Product Service Update 2011[®]

EVINRUDE[®]
E-TEC[®]

Product Service Update

Engine Wiring Harness Change 15 – 30 HP Models

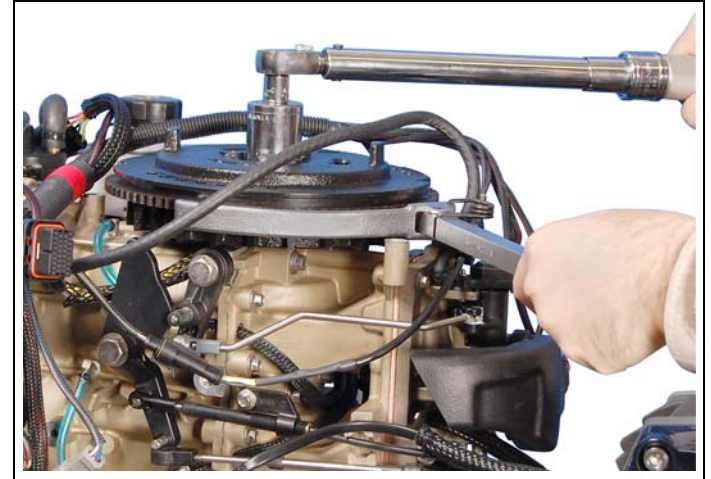
Evinrude E-TEC 15 – 30 HP (C, H, R, and S-suffix) model outboards have a new engine wiring harness to support changes to the *Touch Troll* and neutral switches.

The *Touch Troll* switch connector has been eliminated. Wiring for the *Touch Troll* switch has been relocated to a new 6-pin AMP connector of the tiller harness. The neutral switch has a dedicated 2-pin AMP connector, similar to other *Evinrude E-TEC* models.

Exhaust Housings 40 – 65 HP Models

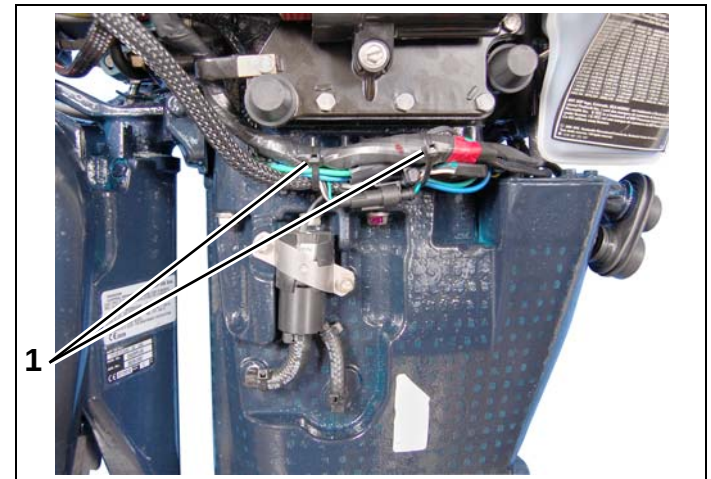
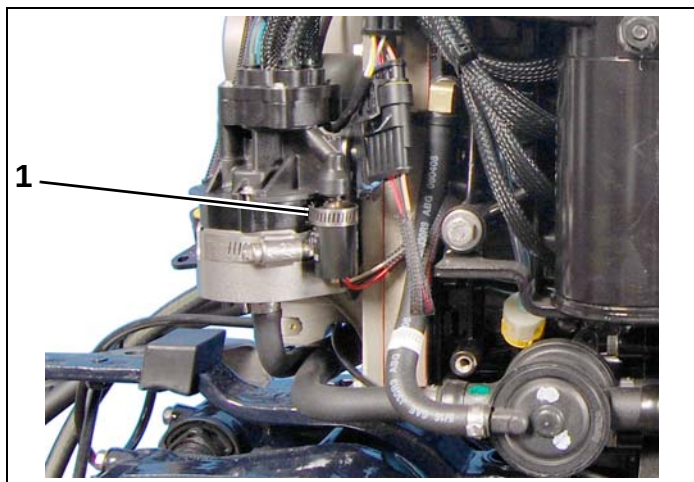
A change was made to the exhaust housing for 40 – 65 HP models.

Retainer tabs have been added to the exhaust housing to better secure the engine wiring harness. Tie straps are now used to secure the engine wiring harness, rather than the previous “J-clamps.”

This change also makes it easier to reinstall and secure the engine wiring harness when servicing the engine.

Oil Pressure Sensor 115 – 300 HP Models

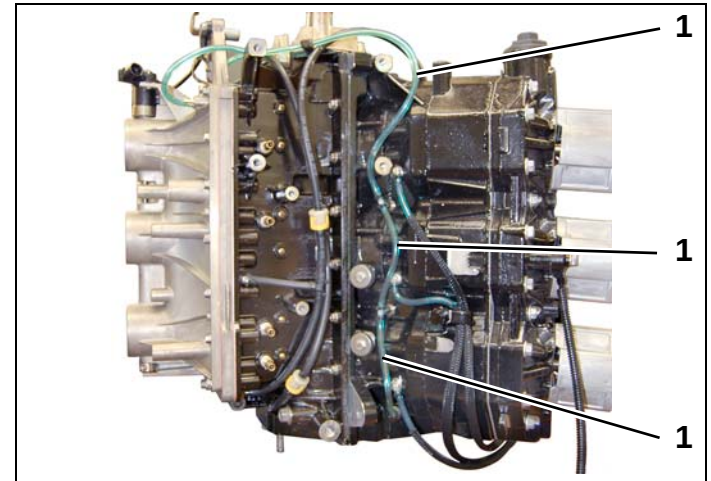
Clamp, P/N 982115, is now used to retain the oil pressure sensor to the oil pump housing on all V4 and V6 models.

This change improves the retention of the oil pressure sensor and provides common service parts for these models.

Shift Switch 200 – 300 HP 90° V6 Models

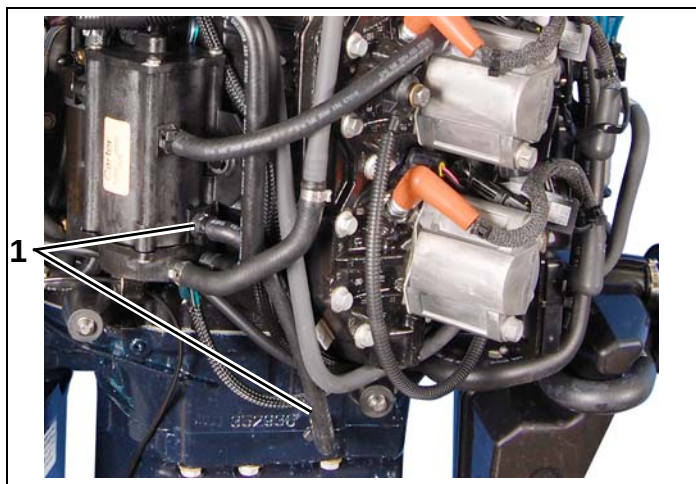
Shift switch, P/N 586861, has been relocated from the shift linkage to the cylinder and crankcase. This change improves the operation of the shift switch.

Cooling System Change 250 – 300 HP 90° V6 (3.4 L) Models

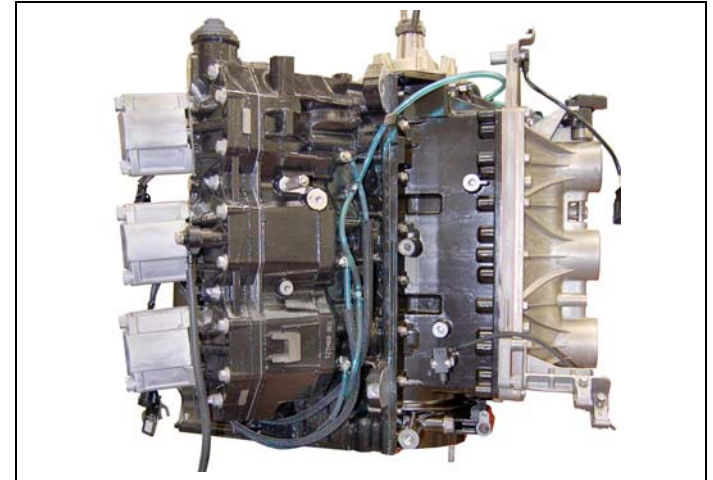
The cooling water hose from the vapor separator outlet to the exhaust adapter has been relocated to the exhaust emission test port of the exhaust adapter.

This change improves water pressure to the powerhead and provides additional water to cool the propeller hub.

Hydraulic Trim and Tilt Assembly
1. P/N 5007776, Black anodized manifold

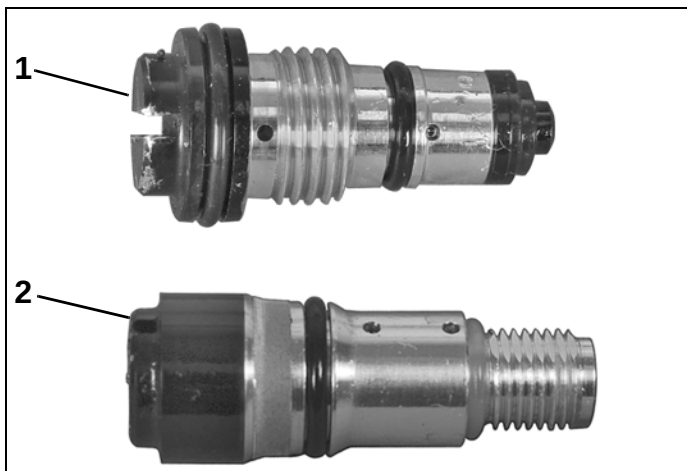
If a hydraulic trim and tilt assembly, P/N 5007776, cannot be lifted manually, replace the manual release valve, P/N 5007782. The replacement manual release valve is identified by its red anodized color.

Exhaust Housing to Gearcase Alignment Pins

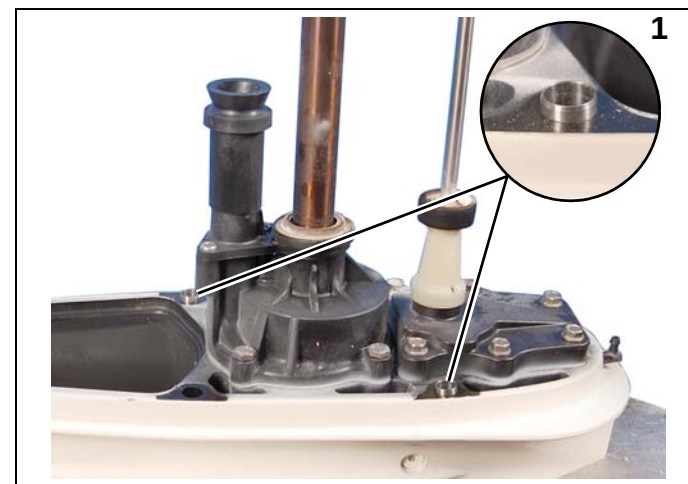
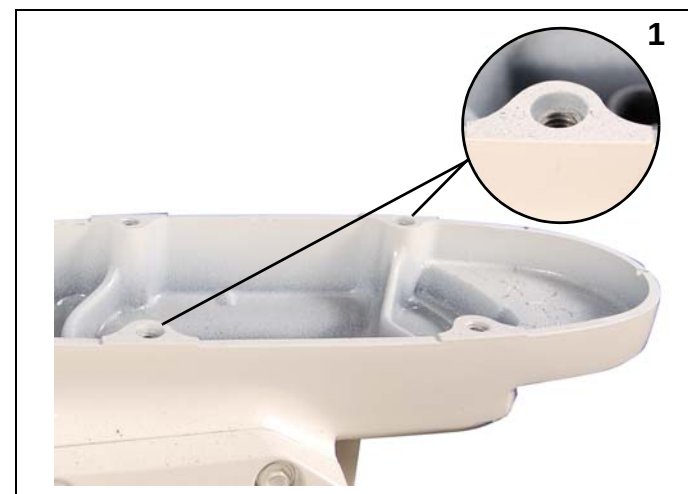
Current production M2-Type gearcases are fitted with exhaust housing to gearcase alignment pins, P/N 350943.

If installing a replacement M2-Type gearcase on a 2008 or older engine, inspect the exhaust housing. Make sure it is machined to accept the exhaust housing to gearcase alignment pins.

If the exhaust housing is not machined to accept the alignment pins, remove the alignment pins from the replacement gearcase.

NOTICE Failure to remove the exhaust housing to gearcase alignment pins can damage the exhaust housing mounting flange and prevent correct installation of the gearcase.

Use Gearcase Alignment Kit, P/N 5007231 to accurately align gearcase housing to exhaust housing on engines where the exhaust housing is not machined to accept the alignment pins.
